Response to Reviewer 1

I have read the paper, “DAR-type model based on "long memory-threshold" structure: a competitor for daily streamflow prediction under changing environment”. Overall, the paper aims to develop and test a stochastic model for simulating daily streamflow, taking care of the nonlinearity, nonstationarity, and most importantly, the long-term memory of the streamflow. This is one of the few papers in the field of stochastic hydrology that has devoted greater attention to reproducing the long-term memory component of streamflow, which is really appreciated.

Figure 2: Characteristics tests designed to detect long-term memory, nonstationarity, ARCH effect and nonlinearity in daily streamflow time series."

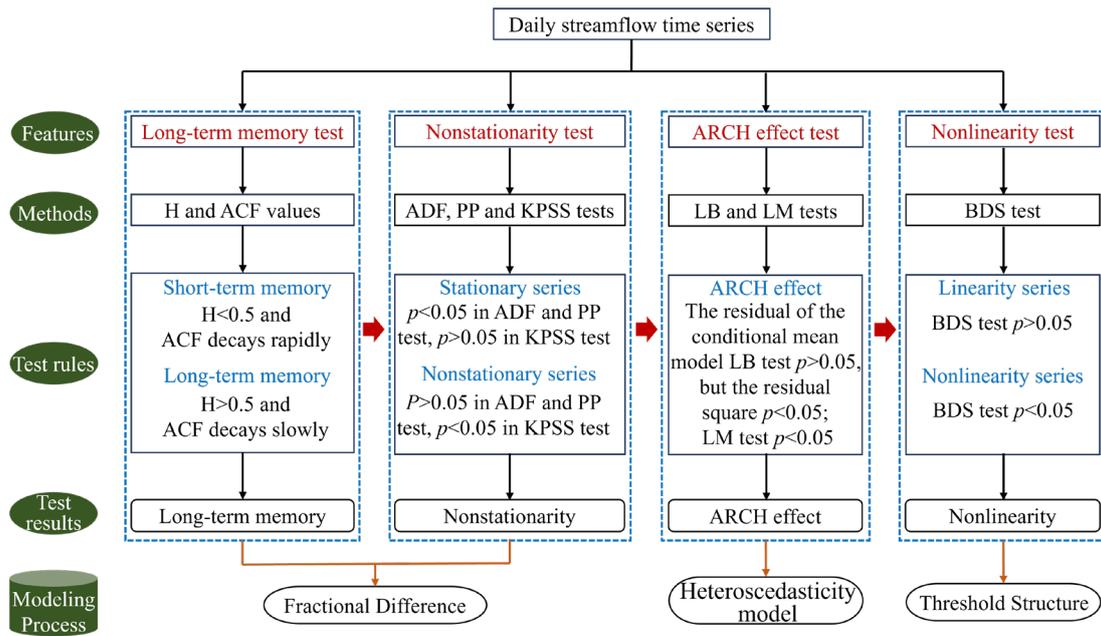
- Section 2.3: This section, in the current form, is the most confusing part in section 2. It portrays different tests on streamflow time series, identifies non-stationarity, confirms the general properties of a white noise process, and examines the contribution of long-term memory to improve the simulation capability of daily streamflow. There are many tests performed here, without enough motivation. It is recommended to reconstruct this section. First, try to state what the overall aim or motivation is for the modeling exercise. Second, with the help of a flowchart, show what hypothesis needs to be tested before going to the modeling exercise. In order to do such hypothesis testing, state the relevant tests with appropriate references. Finally, crisply conclude what is learnt through this modeling exercise and state the next steps to achieve the objective of the paper.

Responses: We sincerely thank the reviewer for the constructive comments on Section 2.3. We fully agree that the original version lacked clarity in structure and motivation, and could potentially confuse the reader due to the number of statistical tests presented without a clearly stated objective. In response, we have substantially revised Section 2.3 to improve its coherence and readability. The revisions include the following key improvements:

We have added a structured hypothesis testing framework to the revised manuscript, supported by a flowchart that outlines the logical flow of the analysis. Relevant references have also been added for each test. The adjustments to this section are detailed in [pages 7-8, lines 128-153](#) of the revised manuscript, which are described as follows: " The daily streamflow time series exhibits seasonal characteristics due to the cyclical influence of the four seasons. Therefore, deseasonalization is a necessary preprocessing step before modeling, with details of the specific method presented in Section 3.1. In this section, the presence of long-term memory in the daily streamflow

series is identified based on the Hurst exponent (H) calculated using the rescaled range (R/S) analysis method and the trend of the autocorrelation function (ACF), and the influence of seasonality on long-term memory is also assessed (Lo, 1991). On this basis, the stationarity of the series is evaluated using three unit root tests: the Augmented Dickey-Fuller (ADF), Phillips-Perron (PP), and Kwiatkowski-Phillips-Schmidt-Shin (KPSS) tests (Dickey and Fuller, 1981; Kwiatkowski et al., 1992; Peter and Perron, 1988). The null hypotheses of ADF and PP tests assume that the time series has a unit root, while the KPSS test considers the null hypothesis as the time series being a stationary process. Due to the tendency of unit root tests to favor the null hypothesis, to rigorously determine the non-stationarity of the daily streamflow time series, if any of the three methods indicates the presence of a unit root process, then the daily streamflow time series at that station is considered non-stationary. Stationarity is a fundamental prerequisite for a model construction. The method of achieving stationarity differs depending on the presence of long memory: non-long-memory series are differenced using integer orders, while long-memory series require fractional differencing. Subsequently, the Ljung-Box (LB) and Lagrange Multiplier (LM) tests are employed to detect the presence of ARCH effects, which is the most critical criterion in building a heteroscedastic model in this study (Ljung and Box, 1978). The ARCH effect reflects the limitations of linear regression models and highlights the necessity of characterizing the variations using a second-order moments. Some studies have suggested a close relationship between ARCH effects and long-term memory in hydrological time series, neglecting long-term memory may lead to spurious detection of ARCH effects (Wang et al., 2023b; Wang et al., 2023c). Therefore, in this section we compare the LB test results of two linear models: a standard integer-order autoregressive model and a long-memory autoregressive (FAR) model based on fractional differencing. Finally, the BDS test is applied to examine whether the series exhibits nonlinear dynamics (Broock et al., 1996). Since most existing heteroscedastic models are constructed based on linear structures, if the series demonstrates significant nonlinearity, it may be necessary to improve the model expression accordingly.

Figure 4: Model building overview diagram

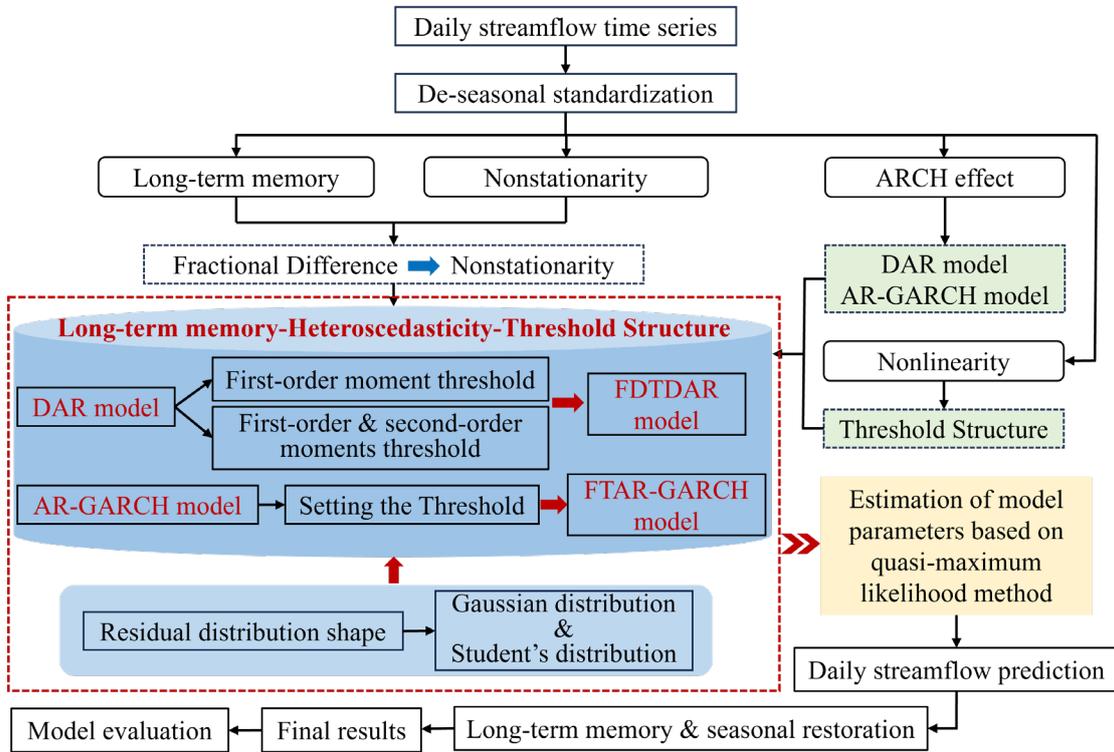
- Before going to section 4, it is recommended to give an illustration of the model selection, parameter estimation, and testing the residuals of the FDTDAR model for a simulation from a standard model. Give a flowchart for this entire model-building process and diagrams related to the key results.

(4) Model building flowchart:

An overview of the process of building the model in this study is shown in Figure 4.
